## Product Change Notice (PCN)

**Subject:** Site addition of package assembly and final test

*Renesas plans to add the site of assembly/final test for RZ/T1 320BGA to realize stable supply. Renesas would like to deliver product produced in the added site for your orders. However, booking part number is changed for identification because a part of package drawing is changed from current product. We would highly appreciate it if you could confirm the following items and approve our plan.*

Package outline:

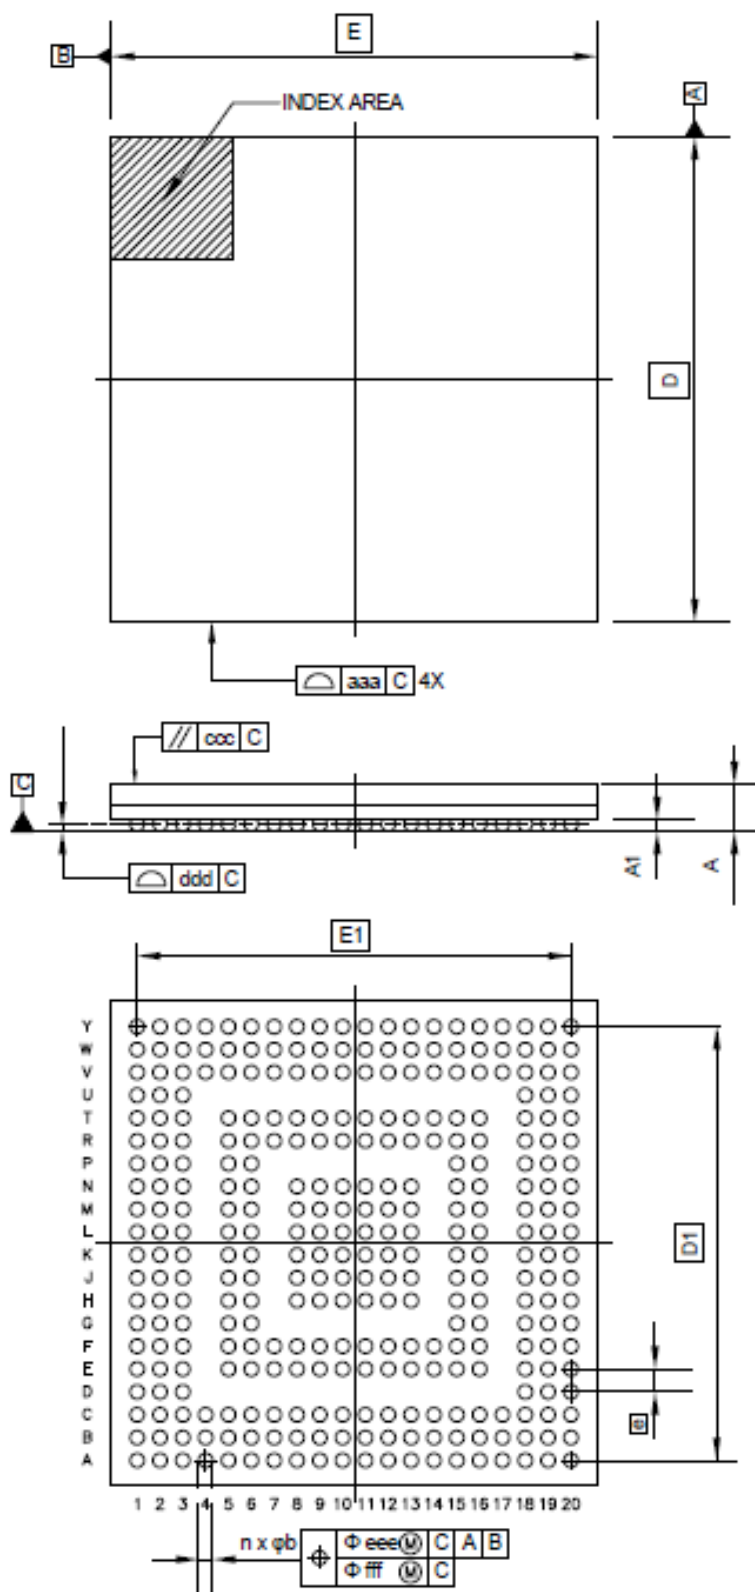
Package total thickness (max.) is changed from 2.3 mm to 1.75 mm and coplanarity (max.) is changed from 0.10 mm to 0.12 mm, because of assembly site change.

Current product					Additional product				
	Symbol	Dimension in Millimeters				Symbol	Dimension in Millimeters		
		Min.	Nom.	Max.			Min.	Nom.	Max.
Package size	D	16.80	17.00	17.20	Package size	D	16.80	17.00	17.20
Package size	E	16.80	17.00	17.20	Package size	E	16.80	17.00	17.20
Total thickness	A	-	-	2.30	Total thickness	A	-	-	<b>1.75</b>
Stand off	A1	0.35	0.40	0.45	Stand off	A1	0.35	0.40	0.45
Ball pitch	e	-	0.80	-	Ball pitch	e	-	0.80	-
Ball width	b	0.45	0.50	0.55	Ball width	b	0.45	0.50	0.55
Ball offset (Package)	x1	-	-	0.20	Ball offset (Package)	x1	-	-	0.20
Ball offset (Ball)	x2	-	-	0.08	Ball offset (Ball)	x2	-	-	0.08
Coplanarity	y	-	-	0.10	Coplanarity	y	-	-	<b>0.12</b>
Mold parallelism	y1	-	-	0.20	Mold parallelism	y1	-	-	0.20

Reference Symbol	Dimension in Millimeters		
	Min.	Nom.	Max.
D	—	17.00	—
E	—	17.00	—
D1	—	15.20	—
E1	—	15.20	—
A	—	—	1.75
A1	0.35	—	—
b	0.45	0.50	0.55
e	—	0.80	—
aaa	—	—	0.20
ccc	—	—	0.20
ddd	—	—	0.12
eee	—	—	0.20
fff	—	—	0.08
n	—	320	—
